City of Burlingame

Meeting Minutes Planning Commission

- d. 988 Howard Avenue, zoned MMU - Environmental scoping and Design Review for an application for Environmental Review, Commercial Design Review, Conditional Use Permit for building height, and Setback Variance and Parking Variance for a new 3-story commercial building (Dimitrios Sogas, applicant; Robert Lugliani, property owner; Toby Levy Design Partners, architect) (42 noticed) Staff Contact: Catherine Barber

Subject: Request for Environmental Review, Commercial Design Review, Conditional Use Permit for building height, and Setback and Parking Variances for construction of a new 3-story commercial building with a roof deck at **988 Howard Avenue, zoned MMU, APN: 029-214-220**

FLOOR PLAN:
GROUND FLOOR

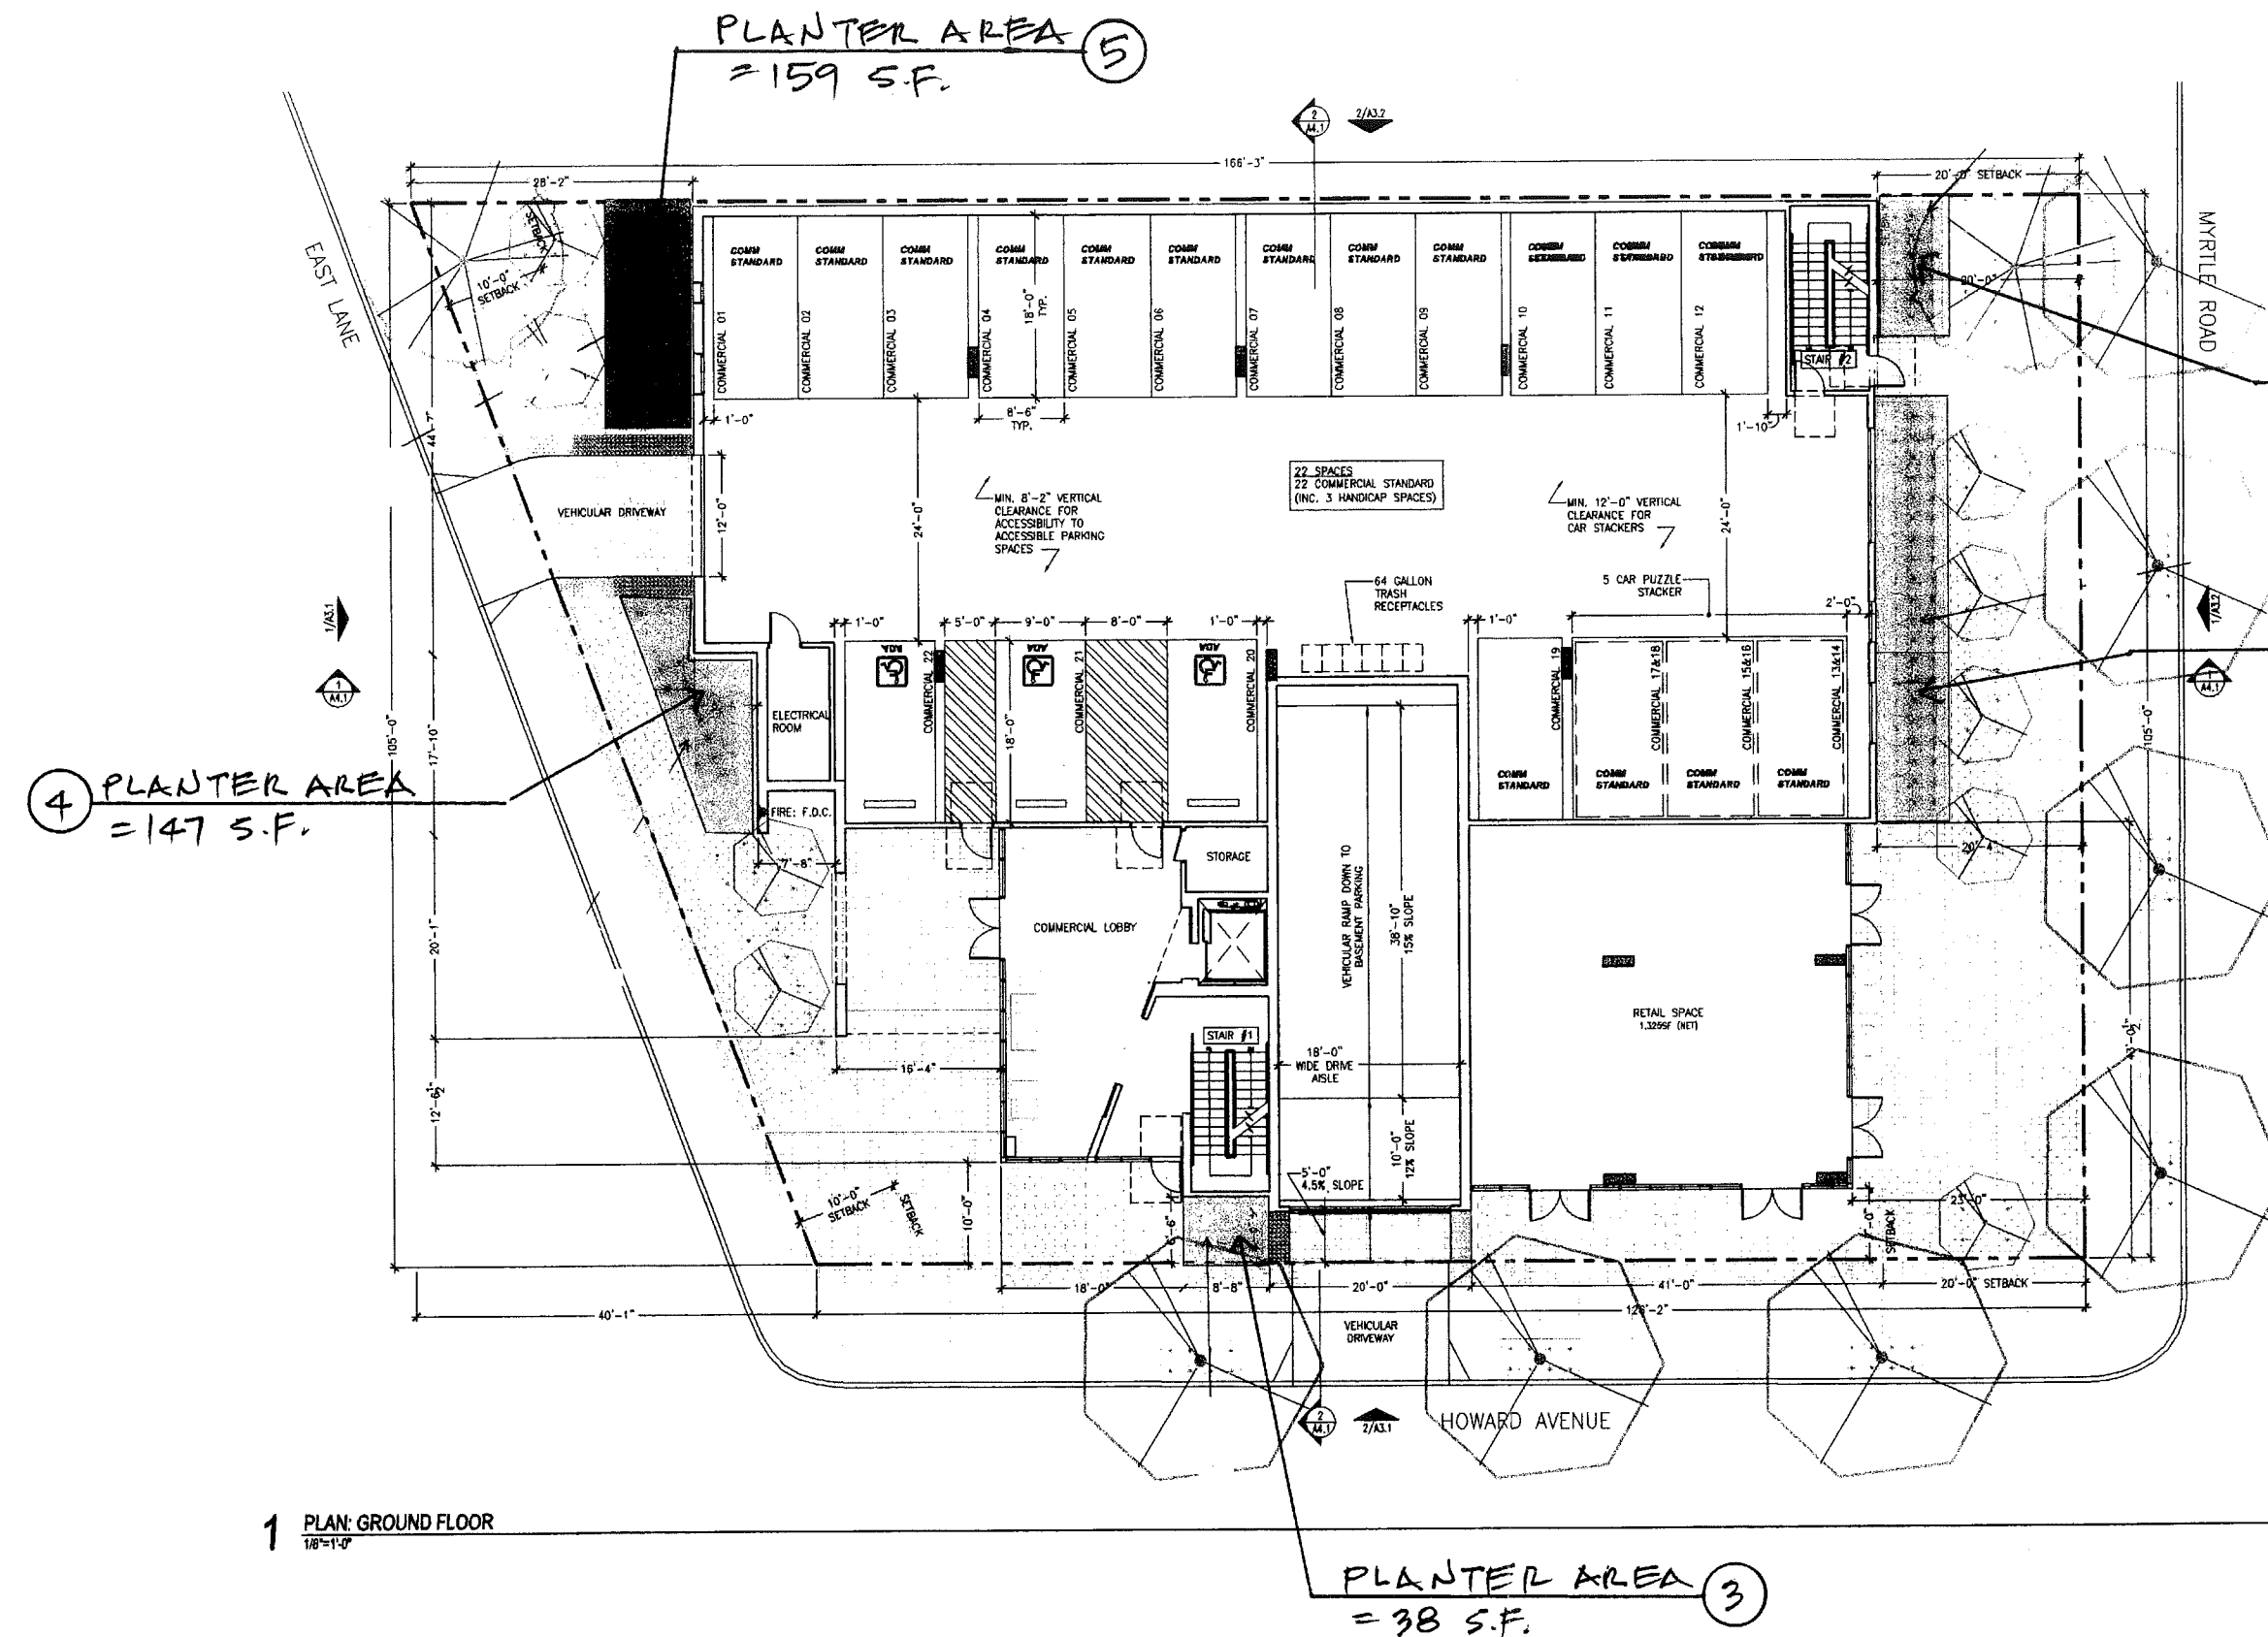
- 31) In the commercial space shown on sheet A2.1 provide details that show a minimum of one accessible Uni-sex restroom in the tenant space.
- 32) Provide details on the plans which show that the entire site complies with all accessibility standards. NOTE: If full accessible compliance cannot be achieved complete the attached *Request for Unreasonable Hardship*.

- 44) Remove all references to the ADA (see the accessible parking on sheet A2.1) as this project must comply with the 2015 CBC, Chapter 11B not the ADA.
